Number: SB 2X-27-16

Issued: October 02, 2009

SNS SUBJECT: 27-50 Flaps - Flap Actuator Modification

Figure 01
Flap Actuator Modification (Page 1 of 2)

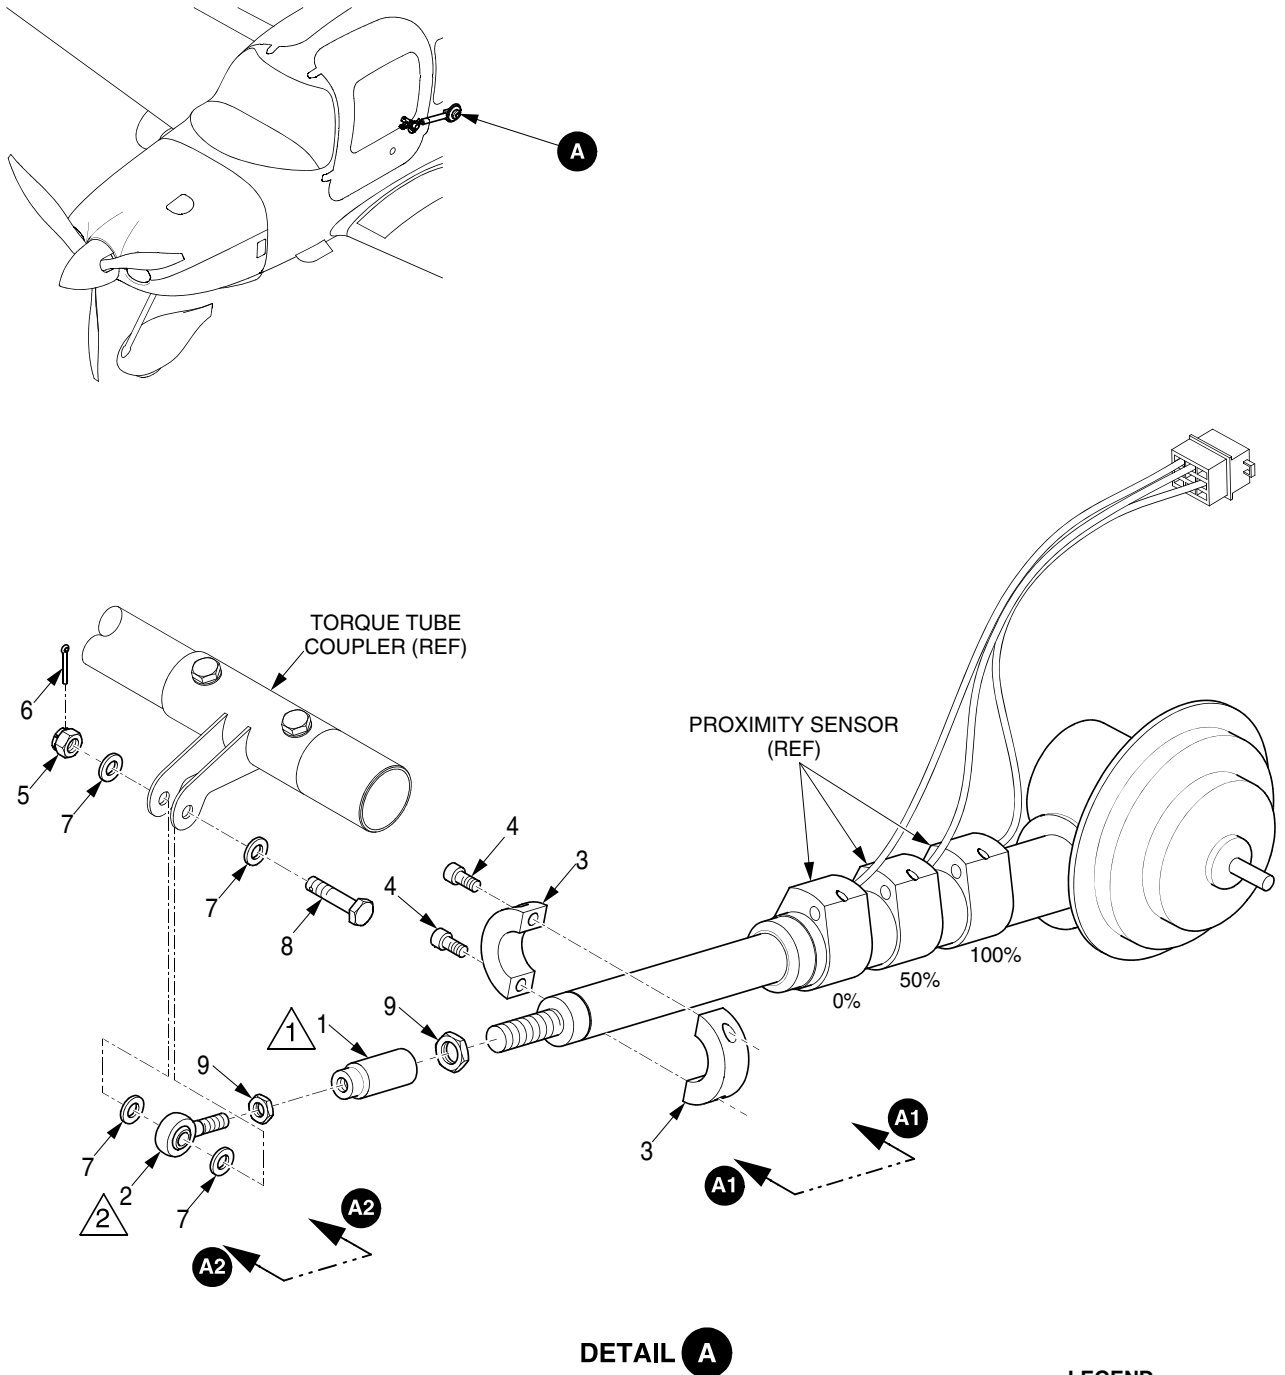
To prevent this condition from occurring, this Service Bulletin installs a collar to the flap actuator to prevent the actuator from over-extending and replaces the actuator end fitting and rod end with versions of a new design. These combined changes reduce actuator travel in the event of a sensor failure.

This Service Bulletin contains instructions for the modification of the placement of the flap actuator sensors, replacement of the actuator end fitting and rod end, and the addition of a hard stop on the actuator shaft.

- (1) Remove cotter pin, nut, washers, and bolt securing flap actuator to torque tube coupler. Discard nut and cotter pin and retain washers and bolt.
- (2) Loosen jam nut securing rod end to flap actuator end fitting.
- (3) Remove rod end fitting and remove jam nut. Discard rod end fitting and retain jam nut.
- (4) Loosen jam nut securing flap actuator end fitting to flap actuator. Remove and discard end fitting.
- (5) Back jam nut to bottom of flap actuator and install new end fitting (item 1) on actuator.
- (6) Bottom out end fitting on actuator to ensure maximum thread engagement. Tighten jam nut.
- (7) Bottom out existing jam nut onto new rod end (item 2).

- (8) Install rod end into actuator end fitting and bottom out. Leave jam nut loose at this time.
- (9) Cut cable ties securing proximity sensor wiring to flap actuator.
- (10) To facilitate flap rigging, position proximity sensors on flap actuator as follows:
 - (a) Position 0% sensor in approximate location. (See Figure 01)
 - (b) Position 50% sensor 1.0 inch (2.5 cm) from 0% sensor.
 - (c) Position 100% sensor 1.0 inch (2.5 cm) from 50% sensor.
- (11) Reset FLAPS circuit breaker.
- (12) Rotate FLAPS switch to UP position.

- 1 Bottom out end fitting on actuator to ensure maximum thread engagement.
- 2 Bottom out rod end in end fitting. During adjustment, rod end may need to be backed out a maximum of 2 turns.

Figure 01
Flap Actuator Modification (Page 2 of 2)

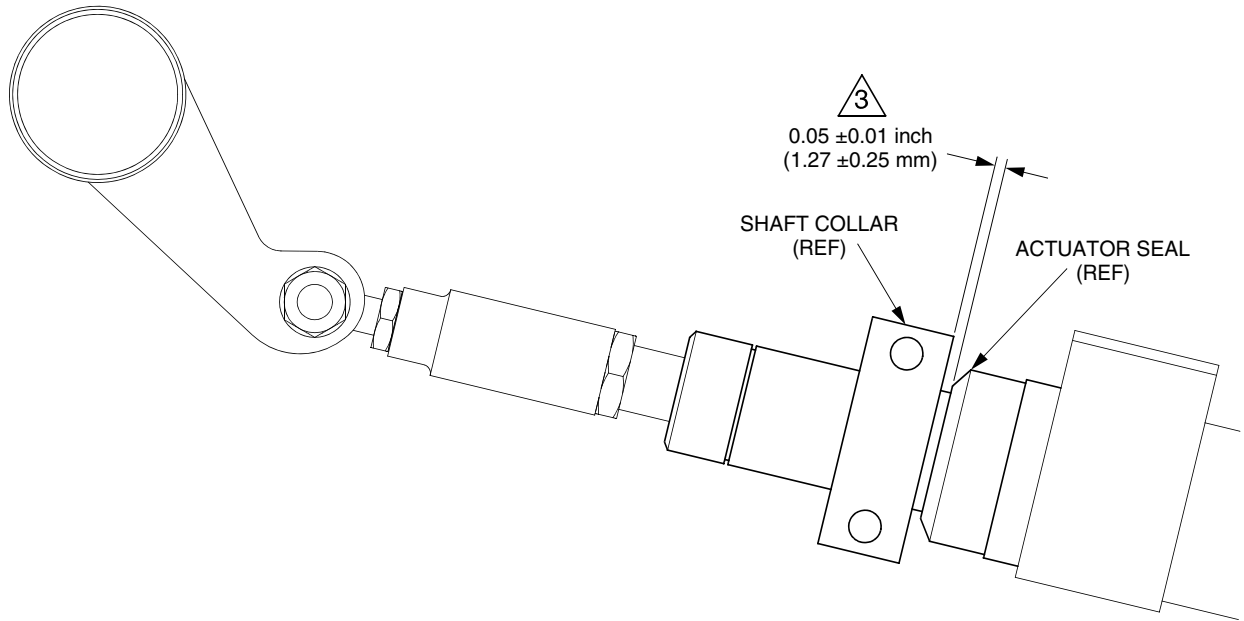
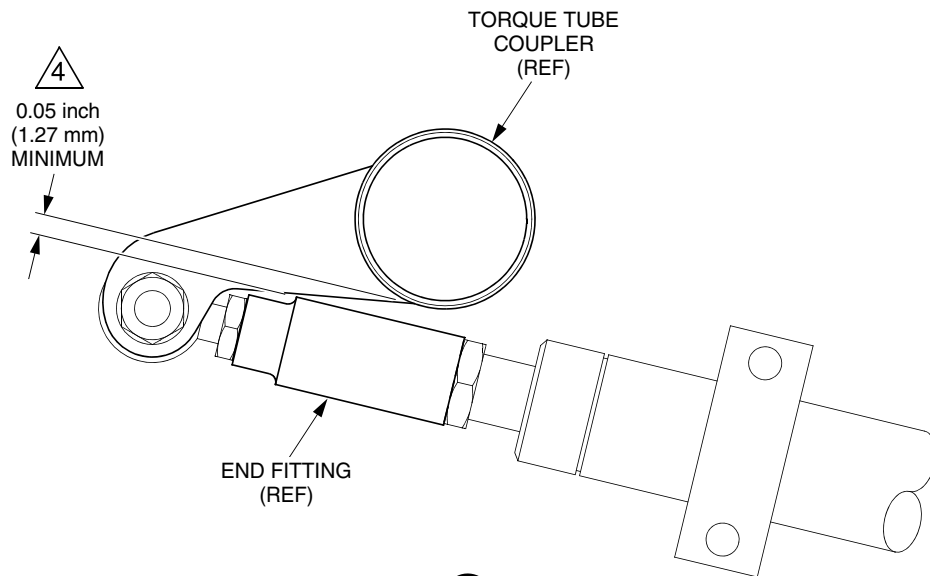
Note: During Adjustment/Test - Flap Travel, it is not necessary to adjust flap actuator end fitting so that flap actuator and rod end connected to torque tube coupler are installed to a depth between end fitting inspection holes. No inspection holes are drilled in new end fitting. Additionally, when in the 0% position, a minimum 0.05 inch (1.27 mm) clearance must be maintained between end fitting and torque tube coupler.

- P. Position collar (item 3) onto shaft of actuator leaving 0.05 ±0.01 inch (1.27 ±0.25 mm) clearance between face of collar and actuator seal.
- Q. Torque collar screws (item 4) to 160.0 ±5.0 in-lb (18.1 ±0.6 Nm).

- △³ With flaps in 100% position, install shaft collar on actuator shaft with 0.05 ± 0.01 inch (1.27 ± 0.25 mm) gap between face of collar and actuator seal.
- △⁴ With flaps in UP position, ensure a minimum gap of 0.05 inch (1.27 mm) exists between end fitting and torque tube coupler.
